CITY OF ALBUQUERQUE

October 9, 2018

RE: Maverik Fuel Center
3737 Princeton Drive NE
Grading and Drainage Plan & Drainage Report
Engineer's Stamp Date: 10/03/18
Hydrology File: G16D029

Based upon the information provided in your submittal received 10/03/2018, the Grading & Drainage Plan and Drainage Report **are not** approved for Building Permit and SO-19 Permit. The following comments need to be addressed for approval of the above referenced project:

ENGINEER'S SEAL RONALD R. BOHANNAN P.E. #7868	MAVERICK INC. STORE ALBUQUERQUE, NM DRAINAGE PLAN	DRAWN BY pm
		DATE 10-28-18
	TERRA WEST, LLC 5571 MIDWAY PARK PL NE ALBUQUERQUE, NEW MEXICO 87109 (505) 858-3100 www.tierrawestllc.com	DRAWING 2018039-GR SHEET # D1 JOB # 2018039

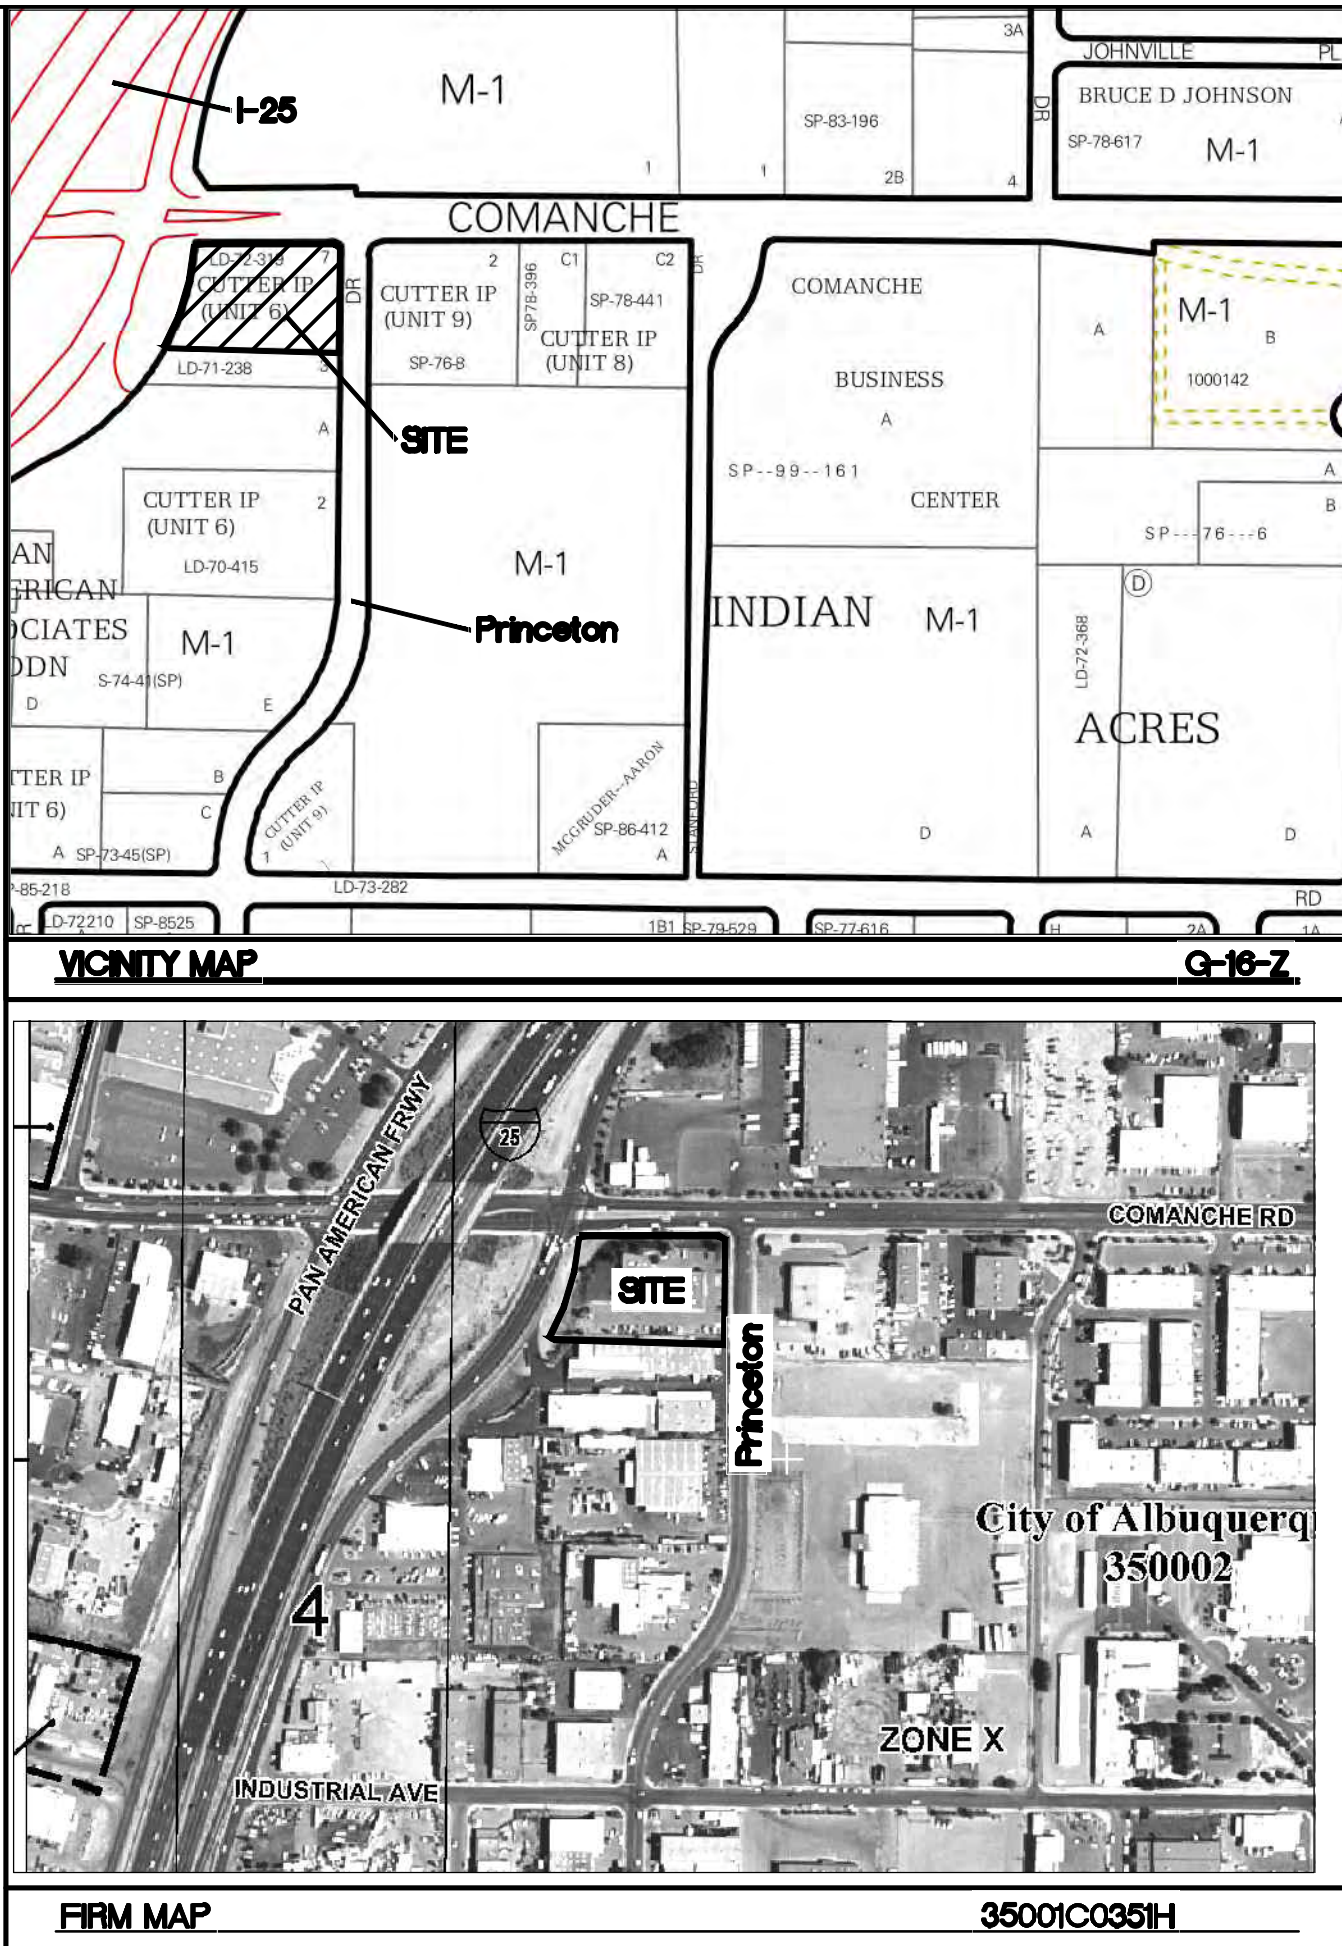
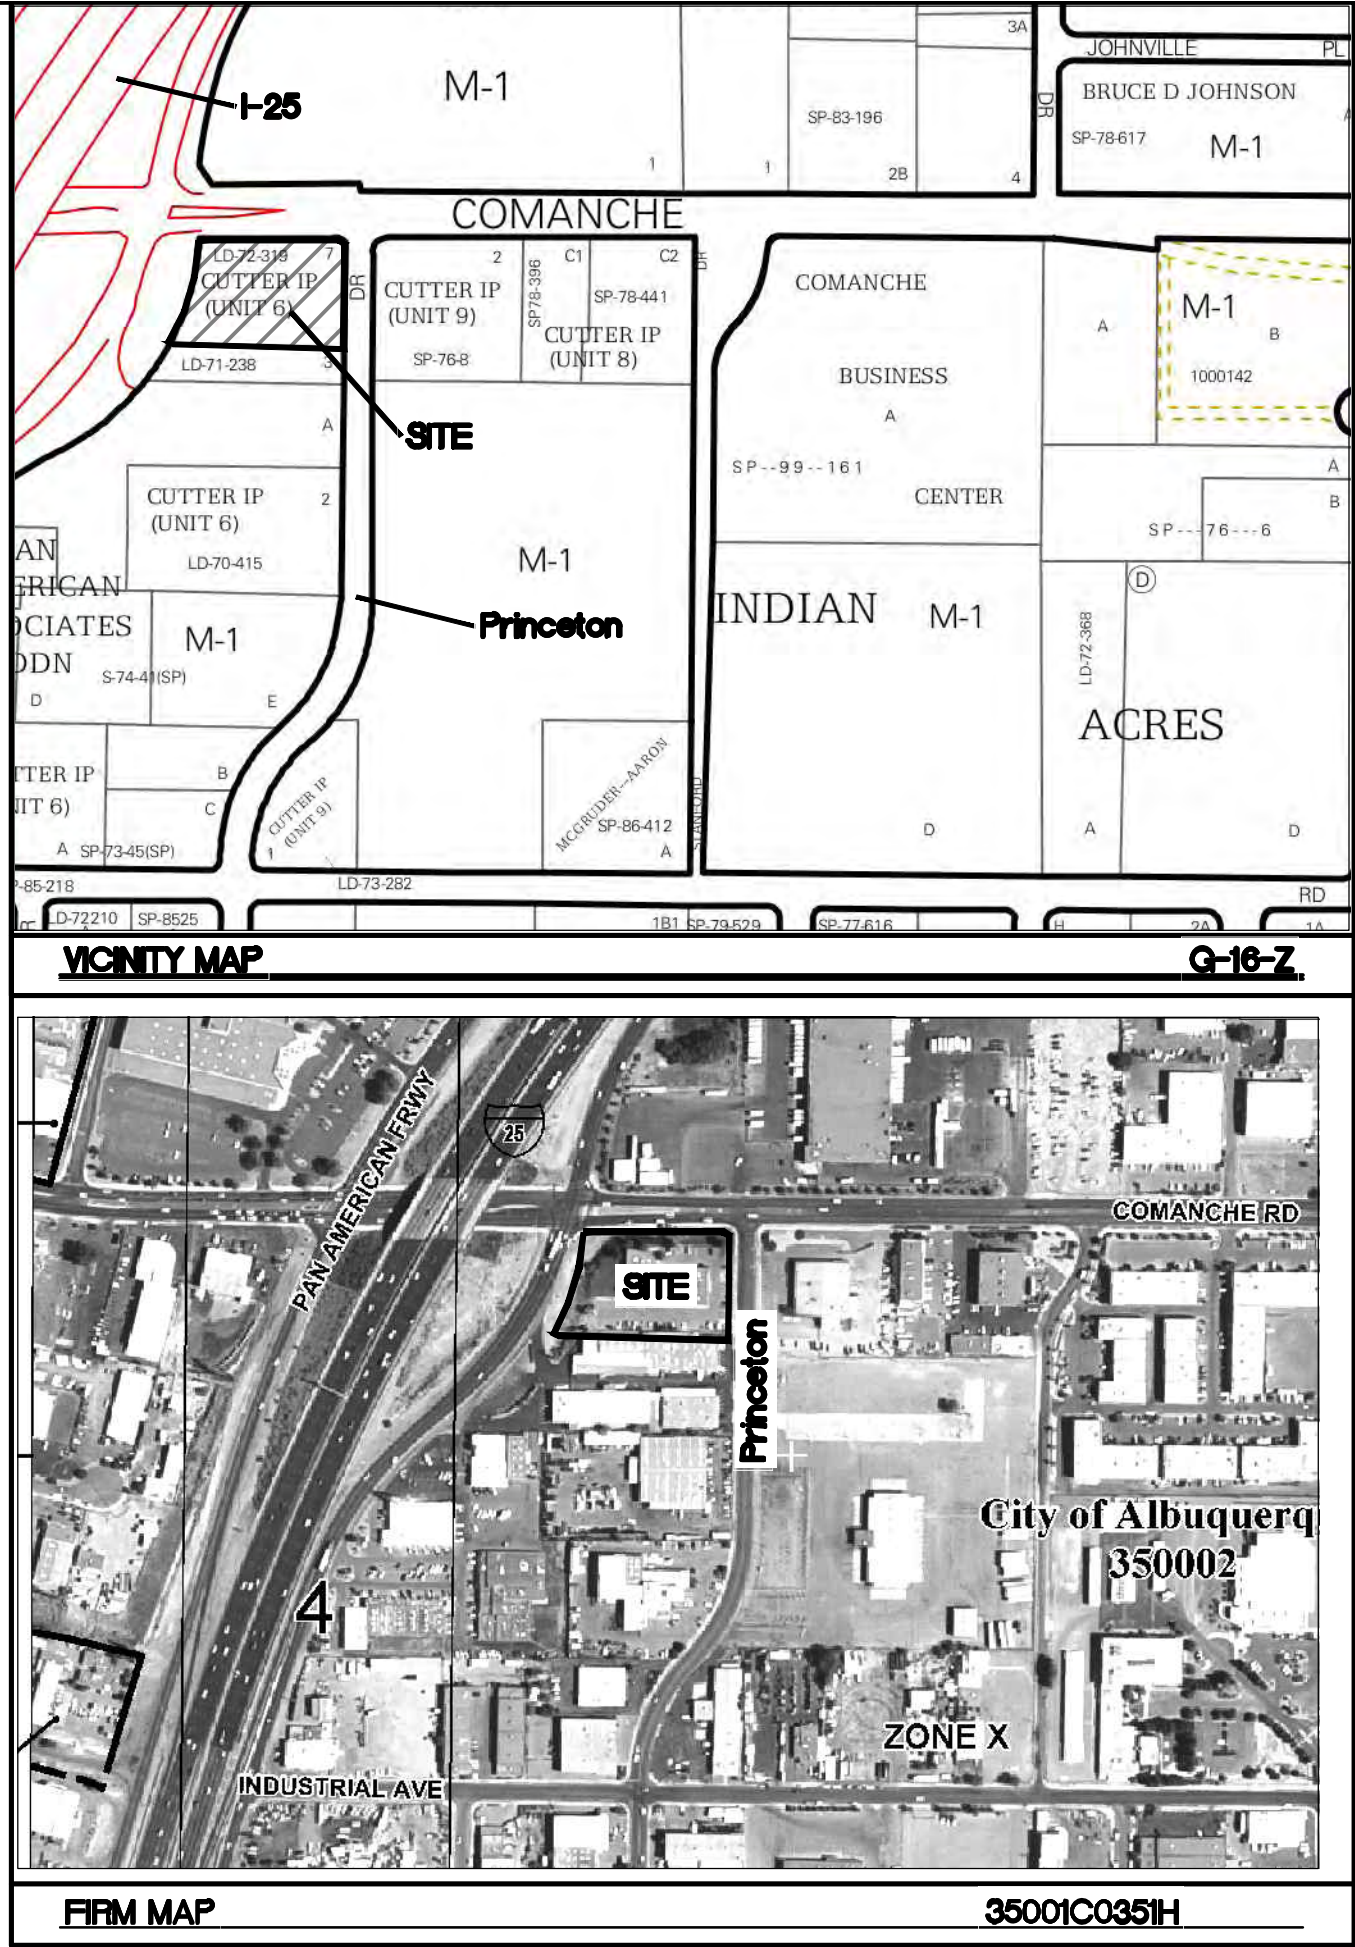
5. Sheet C5. In the water quality pond sections, please change the word "detention" to "water quality".
6. Sheet D1. Please darken the proposed storm sewer pipes so that they can be seen.

7. Sheet D1. Please turn off the accessible path layer. This is not needed on this sheet and is a little confusing with the drainage area lines.

ENGINEER'S SEAL	MAVERICK INC. STORE ALBUQUERQUE, NM	DRAWN BY pm
	GRADING AND DRAINAGE PLAN		DATE 10-28-18
RONALD R. BOHANNAN P.E. #7868		 TIERRA WEST, LLC 5571 MIDWAY PARK PL NE ALBUQUERQUE, NEW MEXICO 87109 (505) 858-3100 www.tierrawestllc.com	DRAWING 2018039-GR
			SHEET # C5
			JOB # 2018039

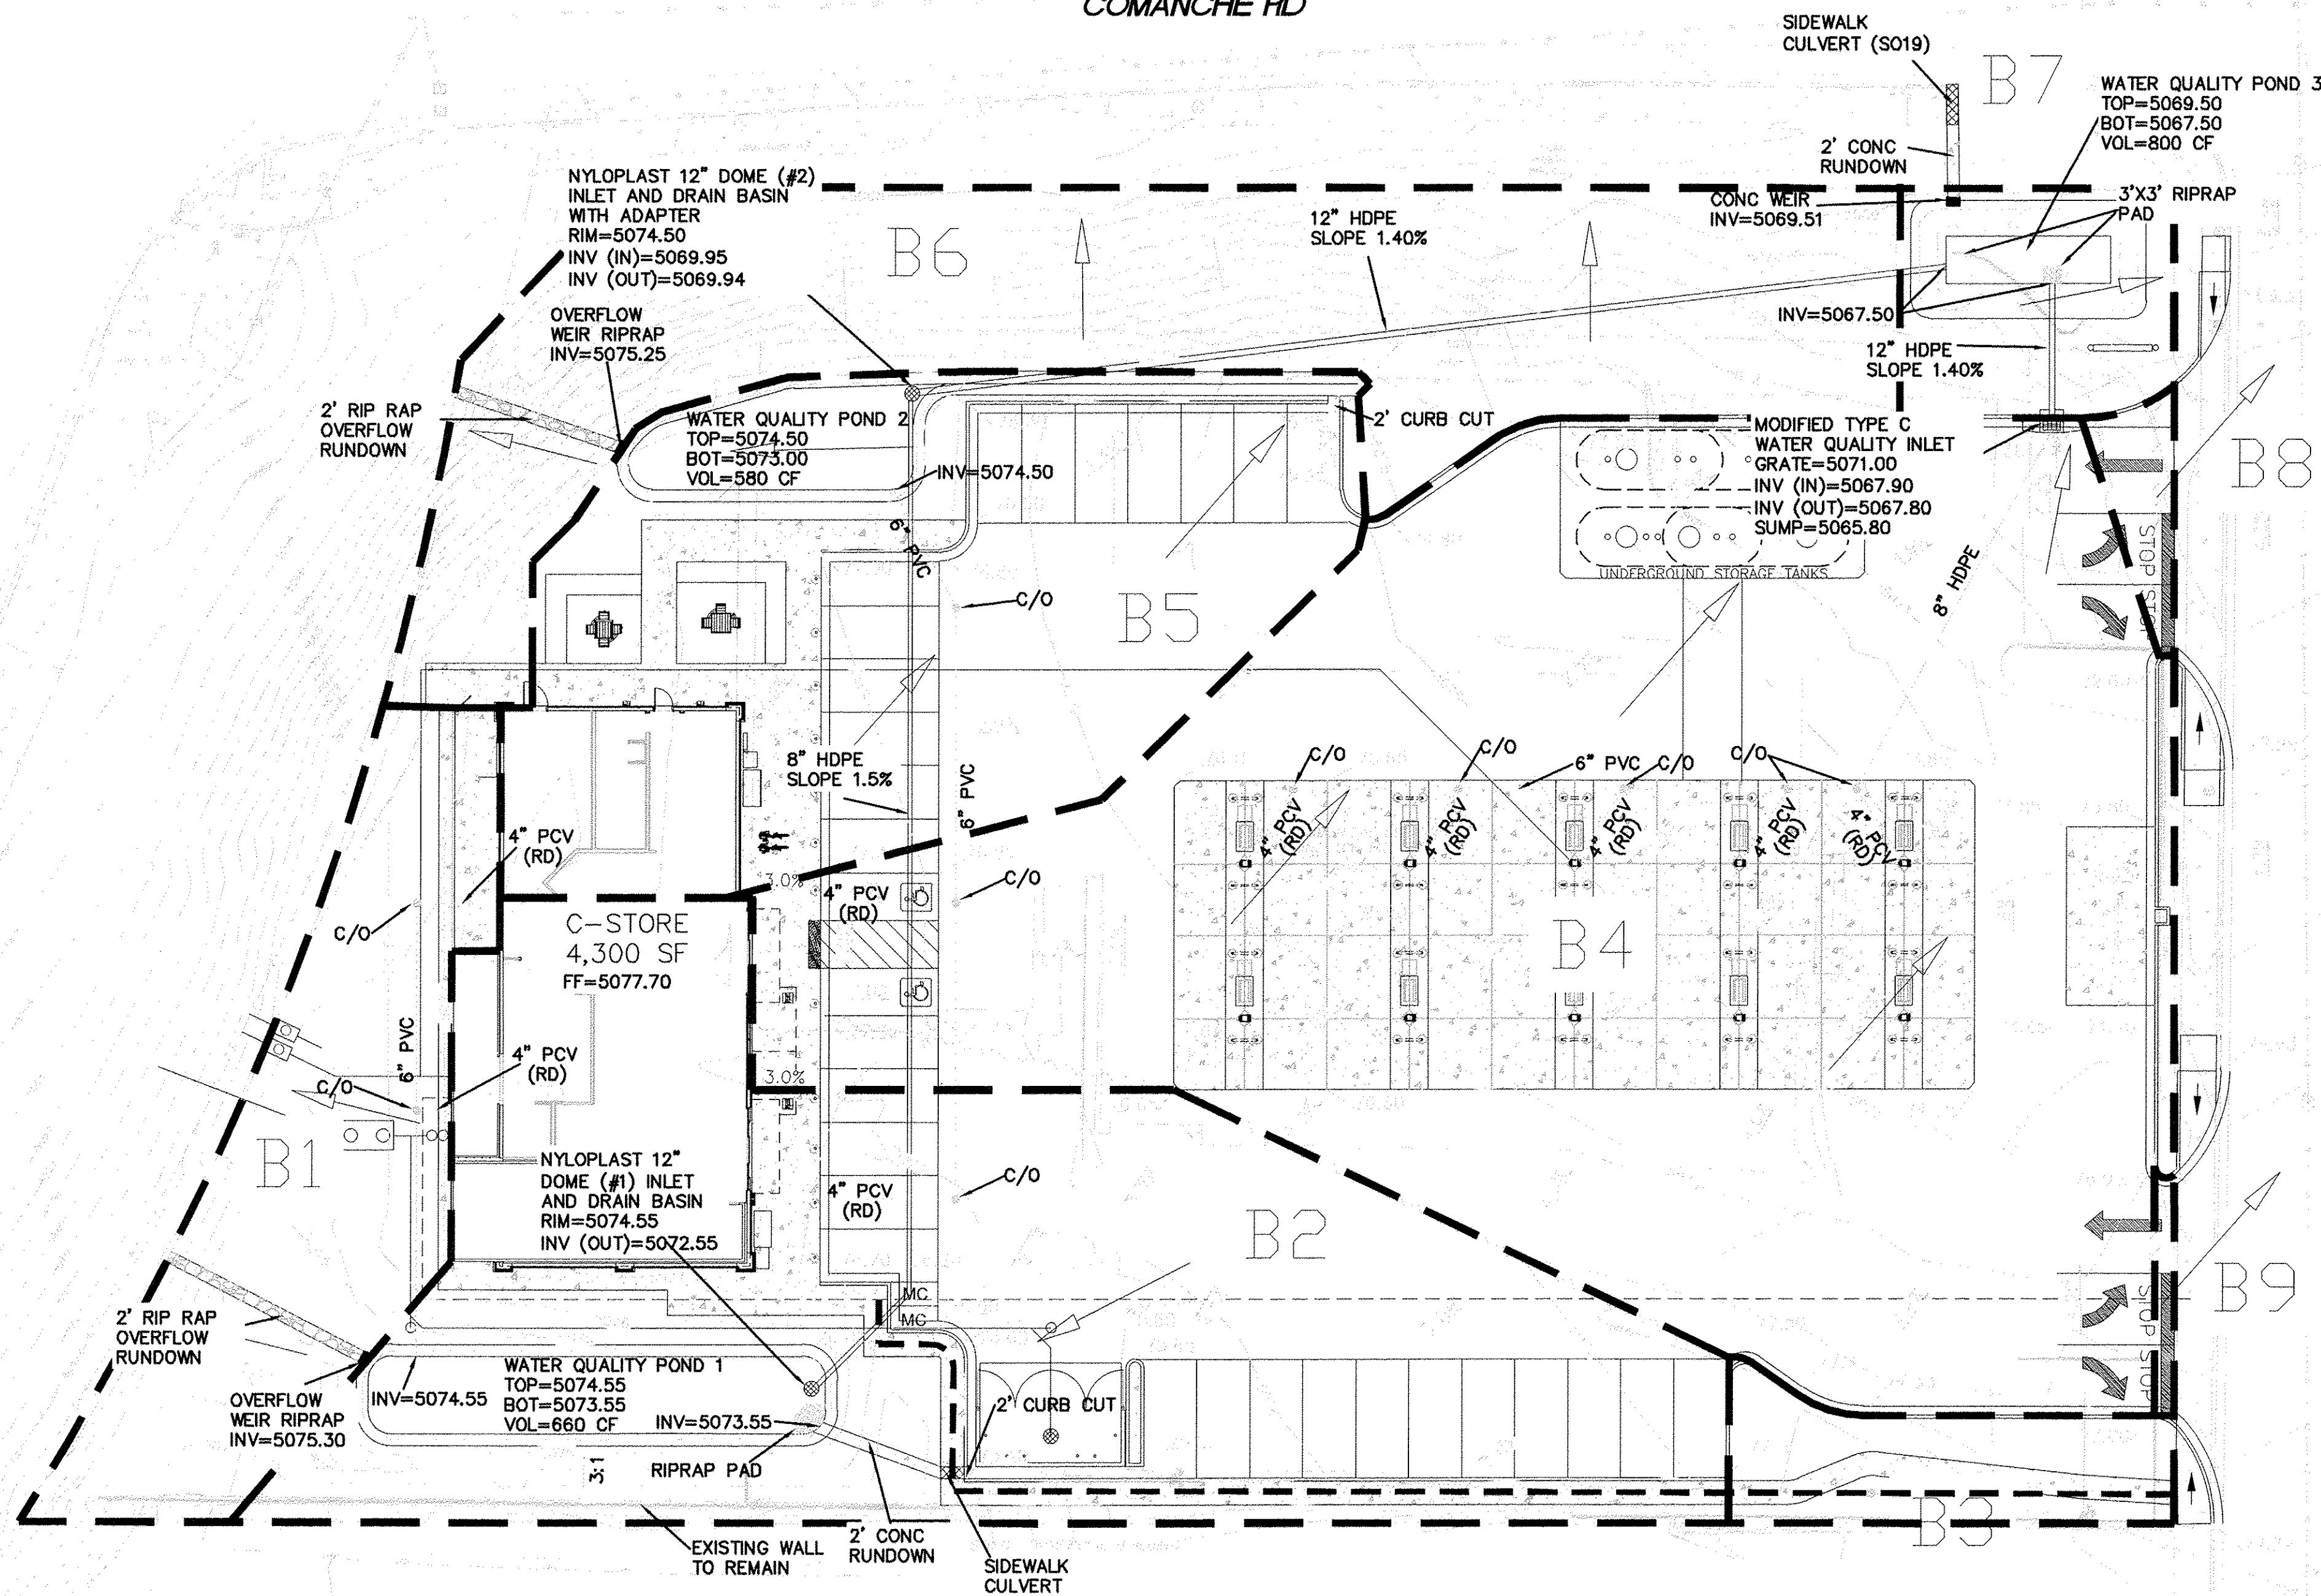
2. Sheet C5. Please provide the FIRM Map's effective date (8/16/12).
3. Sheet C5. Please provide the benchmark information for the survey contour information provided.

4. Sheet C5. Please provide the top of wall and bottom of wall (grade level) of the existing retaining wall at both ends and the middle. Since it appears that there will be some grading on both sides of the wall.
